CITY OF ALBUQUERQUE

**Re: Imperial Building Grading and Drainage Plan
Engineer's Stamp Date 12-8-14 (K14D106)**

Based upon the information provided in your submittal received 12-8-14, the above referenced plan is approved for Site Plan for Building Permit, Building Permit and Work Order with the following discussion.

CG101

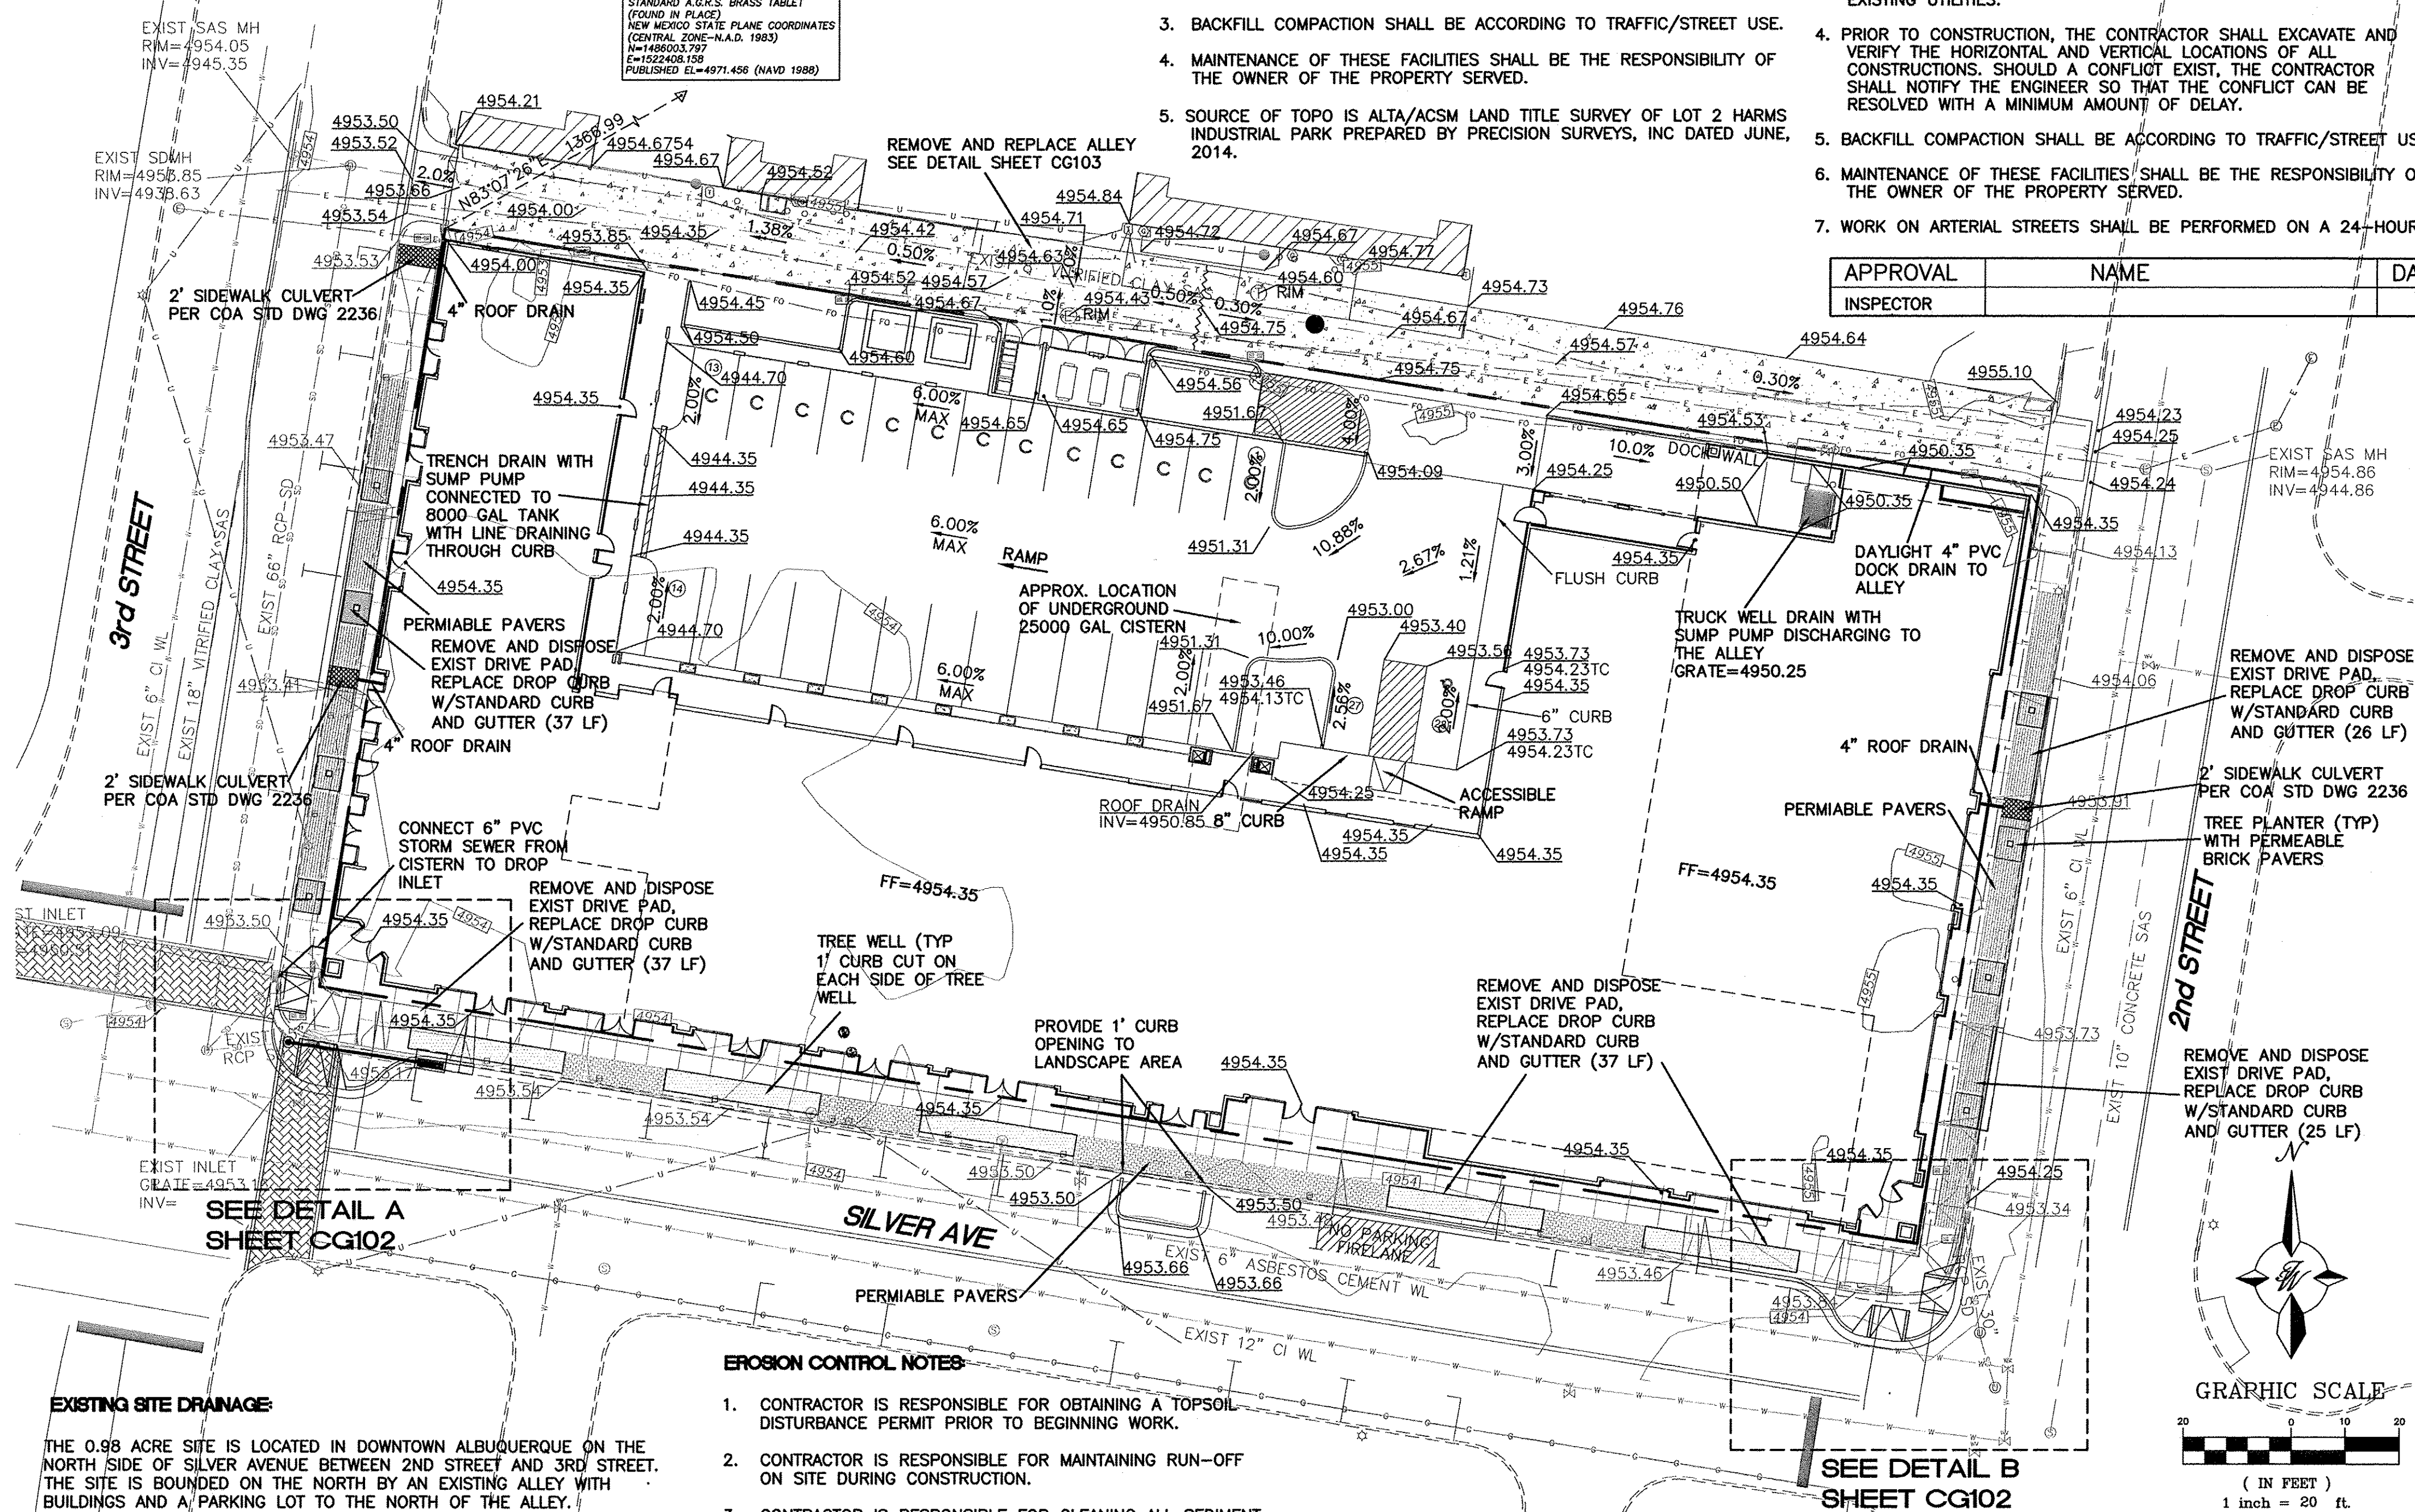
1. The 4" roof drains daylight to proposed 2' wide sidewalk culverts. Seems a 1' sidewalk culvert would work and a 1' sidewalk culvert would be preferred.
2. For brevity just include Sheets CG101 and CG102 in the Work Order for Information Only purposes.
3. SO-19 notes are included on the plan; however, all improvements in City ROW are to be constructed by Work Order.
